REF. : *H.P.ASPI-MN-164*

COMPTE RENDU DE REUNION / MINUTES OF MEETING LIEU / PLACE : *6x Ford - RAL*

SPiRE - Technical progress meeting n°1

<u>SPIRE</u> Technical Progress Meeting n°1	REF.: HP-ASPI-MN-164	
		DATE: 27.06.01	PAGE: 2/9
COMPTRE RENDU DE REUNION / MINUTES OF MEETING		LIEU / PLACE: RAL

Lifetime for the 33 and 49.5 mW options

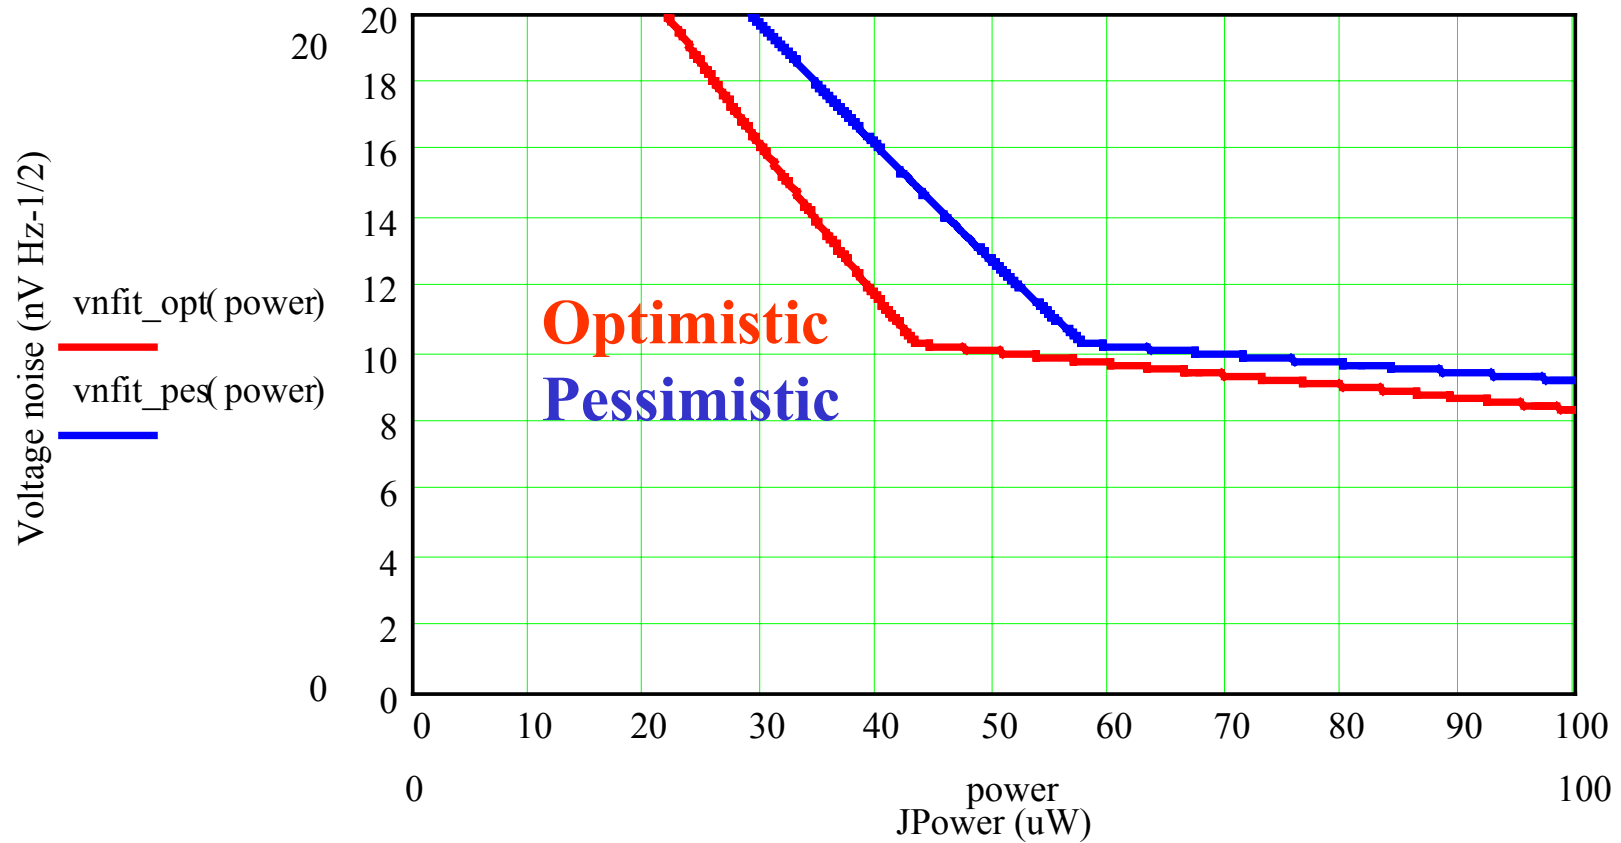
- see M.E. presentation p.34 (impact on lifetime of 50 mW dissipation of JFETs - shown to be ~ -2.3%).
- Analysis appears to show that there is virtually no science advantage achieved with JFETs run with 50 mW, rather than 33 mW. In fact, it implies almost 20% worse science / kg of He.
- JPL is still working towards the 3 mW baseline.

- ↳ the bond for the JFET dissipation in the reduced thermal model is 49.5 mW. The project baseline is 33 mW
- ↳ material of thermal stops (copper or aluminum) and what are the characteristics of  supply (thermal characteristics of the joint)

So the impact on mission lifetime of running at 49.5 vs. 33 mW is around 2.3% at the very most.
